Access Compliance Report

Public Rights-of-Way

(Curb Ramps)

Intersection ID: 12565	Main Street: E_10TH_ST	Cross Street: E_11TH_ST	Location: NW
ADA ID: EC1C0986F607	Ramp Type: Perp	Initial Pass/Fail: Fail	Overall Compliance: No
Severity Score: 12.5			
Codes/Mitigation Info/Possible Solution		Field Measurements/Component Compliance

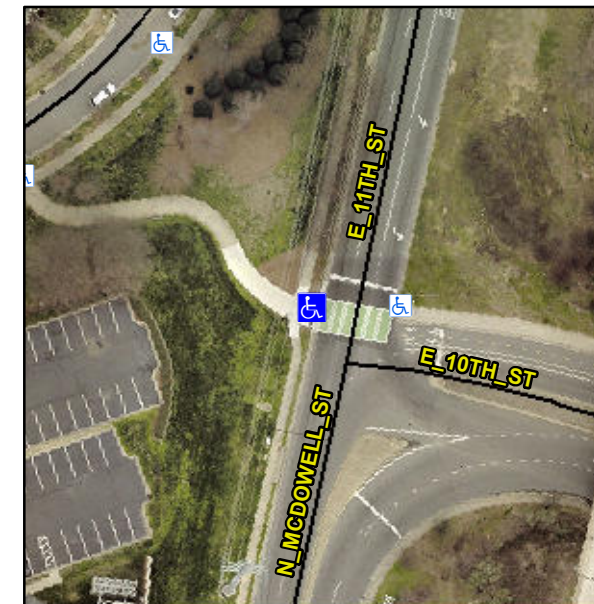
Not Found, R304.2.2

Compliance	Description	Data	Compliance	Description	Data
N/A	Ramp Length (in)	72.5	No	Ramp Slope (%)	8.5
Yes	Ramp Width (in)	48.0	Yes	Ramp XSlope (%)	1.8
N/A	Flare Type LT	N/A	N/A	Flare Type RT	N/A
N/A	Flare Slope LT (%)	N/A	N/A	Flare Slope RT (%)	N/A
N/A	Flare Traversable LT?	N/A	N/A	Flare Traversable RT?	N/A
N/A	Landing Length (in)	N/A	N/A	DWS Provided?	N/A
N/A	Landing Width (in)	N/A	N/A	DWS Contrast?	N/A
N/A	Landing Slope (%)	N/A	N/A	DWS Length (in)	N/A
N/A	Landing X Slope (%)	N/A	N/A	DWS Full Width?	N/A
N/A	Landing Curb? (Y/N)	N/A	N/A	DWS Offset (in)	N/A
N/A	Shared Landing?	N/A			
N/A	Gutter Ponding?	N/A	N/A	Gutter Slope (%)	N/A
N/A	Gutter Lip Ht (in)	2.0	N/A	Gutter X Slope (%)	N/A
N/A	Painted X Walk1?	Yes	N/A	Painted X Walk2?	N/A
	X Walk 1 Direction	To E		X Walk 2 Direction	N/A
N/A	X Walk 1 Width (in)	110.0	N/A	X Walk 2 Width (in)	N/A
	X Walk 1 Slope (%)	0.2		X Walk 2 Slope (%)	N/A
	X Walk 1 X Slope (%)	2.1		X Walk 2 X Slope (%)	N/A

Remove & Replace Entire Ramp.
